Intel[®] Mobile Celeron[™] Processor at 466 MHz, 433 MHz, 400 MHz, 366 MHz, 333 MHz, 300 MHz, and 266 MHz Specification Update

Release Date: February 2001

Order Number: 244444-022

The Intel[®] Mobile Celeron[™] processor at 466 MHz, 433 MHz, 400 MHz, 366 MHz, 333 MHz, 300 MHz, and 266 MHz may contain design defects or errors known as errata which may cause the product to deviate from published specifications. Current characterized errata are documented in this Specification Update.

H29. Thermal Sensor May Assert SMBALERT# Incorrectly

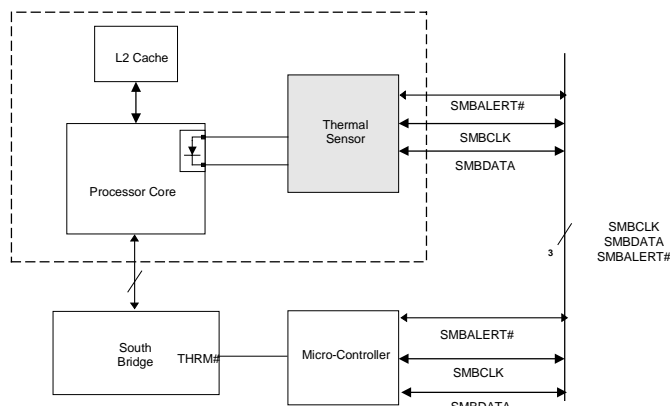
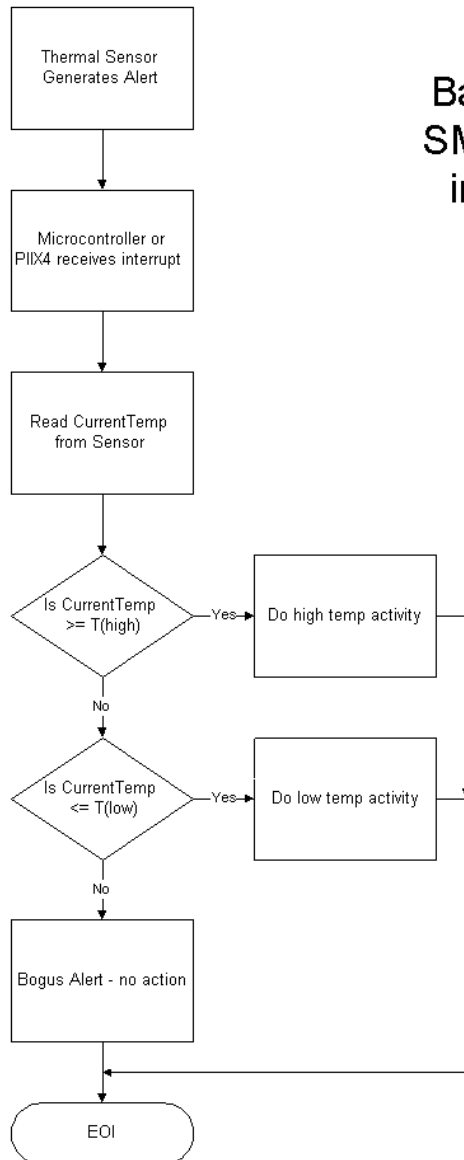
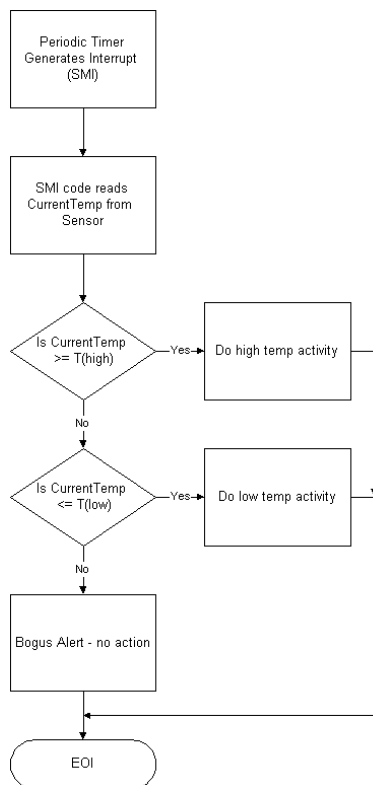
Problem: The Intel Celeron Processor Mobile Module has a thermal sensor that monitors the processor core's temperature. Please note that desktop systems could have a similar thermal device. The thermal sensor asserts SMBALERT# if the processor temperature exceeds the temperature limits set in the Alarm Threshold Registers (T_{HIGH} , T_{LOW}). It also sets the corresponding Status Register bits to identify the cause of the interrupt. Figure 1 gives one example of the how the SMBALERT# signal could be used in a system.

Implication: There is no system impact from this erratum if temperature polling is used for processor thermal management. If the SMBALERT# interrupt is employed to manage processor thermal sensing, then servicing the false interrupt may result in premature system action depending on the software and hardware implementations used. The rate of the false interrupts is less than the auto-convert rate of the thermal sensor.

1. Before servicing an interrupt from the thermal sensor, read and compare the processor thermal reading with the threshold limits (T_{HIGH} or T_{LOW}). Figures 2 and 3 provide basic flowcharts for the implementation of this workaround in an interrupt driven system.
2. If the firmware implemented polls the Status Register only, then before taking any action, re-read the temperature register and do a comparison with the alarm threshold limits (T_{HIGH} or T_{LOW}) to determine if the value is actually still within the temperature window.
3. Use a temperature polling scheme to monitor the processor temperature.

Figure 5.4. Surface-Mount BGA1 Package—Bottom View

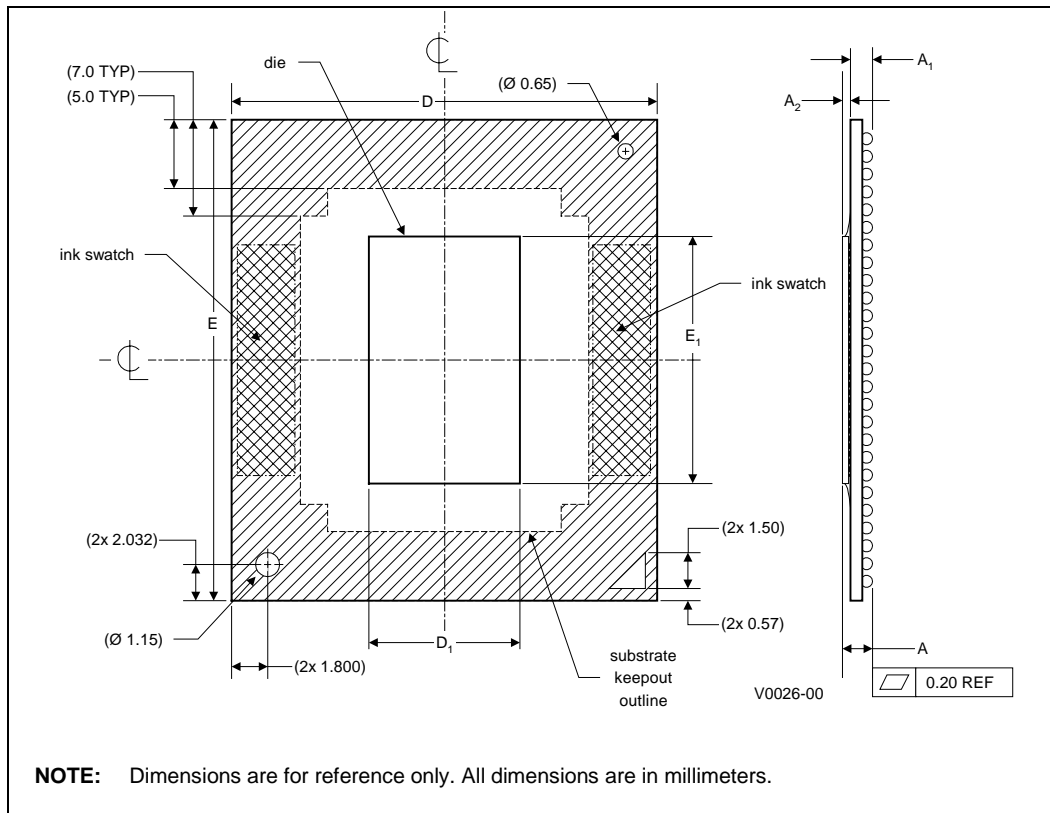
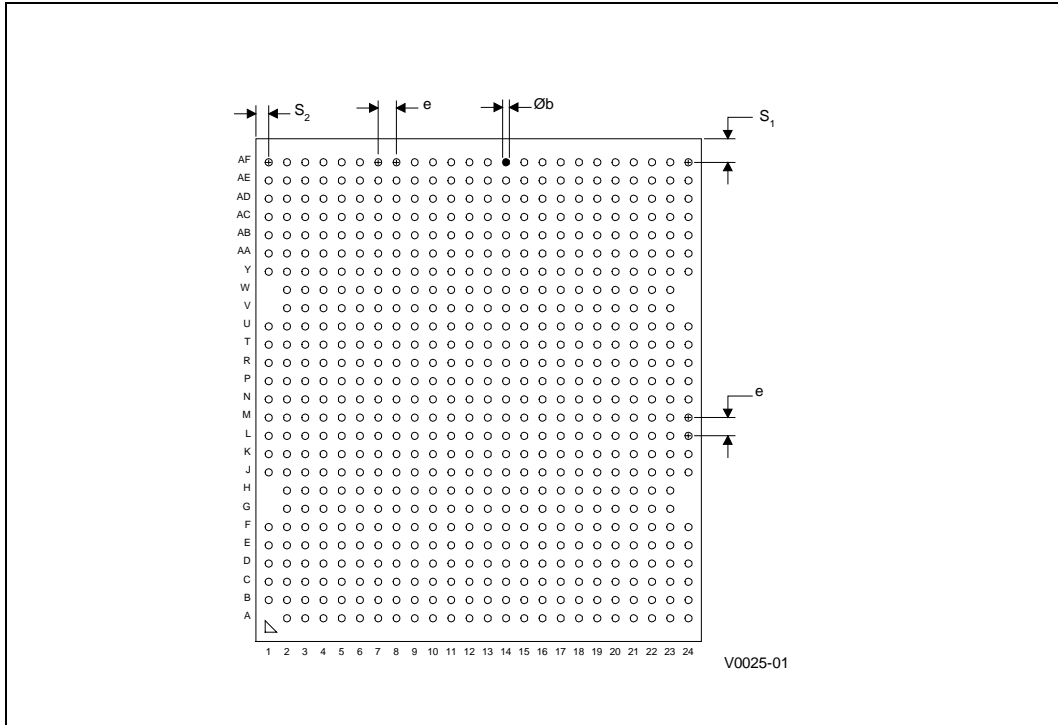
The following table and figures show the updated mechanical specifications for the BGA1 package, listed as Table 5.2, Figure 5.3 and 5.4, respectively, in the *Intel® Mobile Celeron™ Processor in BGA Package at 333 MHz, 300 MHz and 266 MHz* datasheet.

1. The number shown here is different from that in the 244444-004 version of this specification update. The maximum reference number is used.

Figure 3.3 Generic Clock Waveform

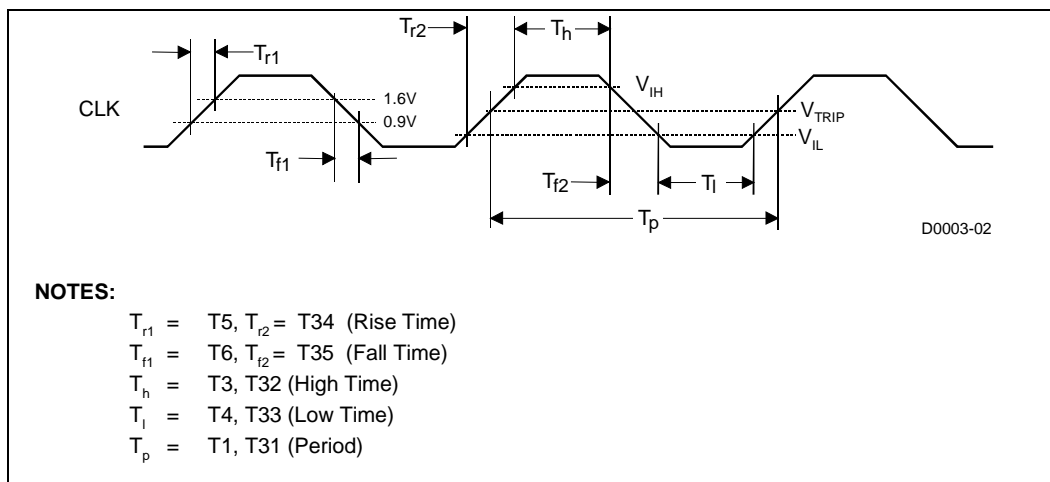
H11. Generic Clock Waveform Figure

Figure 3.3 in the *Intel® Mobile Celeron™ Processor in μ PGA1 and BGA1 Packages at 366 MHz, 333 MHz, 300 MHz, and 266 MHz* datasheet (Order Number 245112-003) has been updated. The following figure is to replace the one in the above document.
